August 3, 2018

**Re: Site C Project – Proposed Changes to the Use of West Pine Quarry for the construction of the Highway 29 realignment, Hudson’s Hope shoreline protection, and areas along the reservoir requiring protection during reservoir filling.**

**APPENDIX A: Proposed Modifications to EIS**

**Portage Mountain and West Pine Quarries  
Haul Routes**

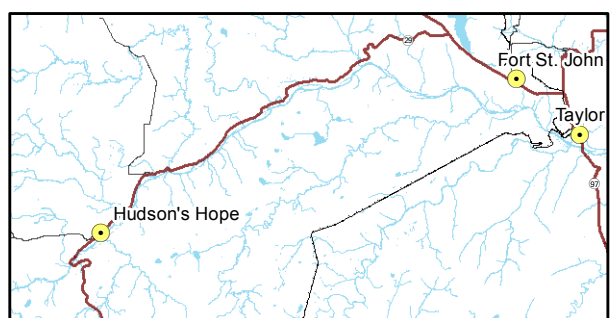
West Pine Quarry is located approximately 73km west of Chetwynd on Highway 97, while Portage Mountain is located west of the existing Peace Canyon Dam, accessed by way of Canyon Drive and Forest Service Roads. Appendix B contains map showing the respective locations and haul routes from Portage Mountain Quarry and West Pine Quarry to Hudson’s Hope. Hudson’s Hope is selected as the end point to both haul routes for this amendment request, as distances farther east along Highway 29 are common to both quarries. The haul routes and distances for both West Pine Quarry and Portage Mountain to Hudson’s Hope are summarized in Table 2.

The hauling distance from West Pine Quarry to Hudson’s Hope is approximately 119 km longer than the distance from Portage Mountain Quarry to Hudson’s Hope. Both haul routes (with the exception of Forest Service Road R14210) are located on numbered provincial highways and public roads. Truck operators will be required to observe and conform to established speed zones and regulatory signage, including restrictions on the use of air brakes within community areas, pedestrian crossings, and school zone speed limits, on these roads. Truck operation and mechanical condition requirements will also be in effect. Such regulatory measures are established by the Ministry of Transportation and Infrastructure (MoTI) and are enforced by police agencies and the Commercial Vehicle Safety Enforcement branch of MoTI per their respective mandates.
